Subject: TCB Services on a 35W Digital Mobile Transceiver (762-870 MHz)

As per Elite Quotation EEE2202062-1 please carry out FCC (C2PC) PAG to the existing Grant / Certification for our Digital Mobile transceiver:

- FCC ID: CASTMBK5B

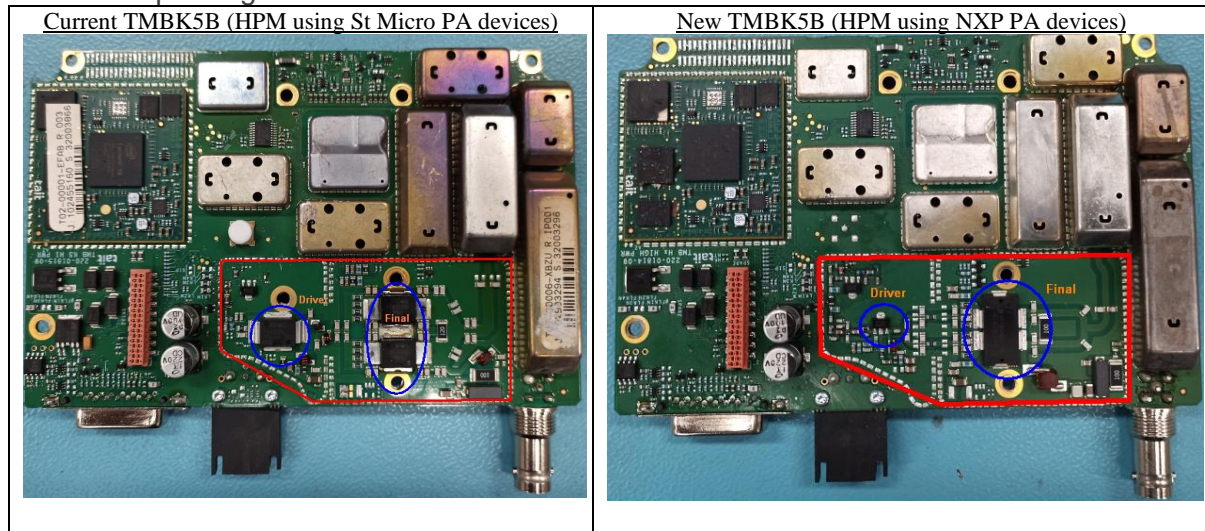
Due to supply chain issues and shortages, the following changes were necessary:

- The 6W (PD85006) driver PA will be replaced with 4W driver (AFT05MS004NT).
- The final PA 2x PD85035S will be replaced with a dual path (AFT09MS055GN).

The circuitry of the VCO, Synthesizer, Exciter, the Tx/Rx PIN and Low Pass Filter remain unchanged.

The pictures below have on the left the current granted hardware and on the right the one we are requesting for a C2PC PAG.
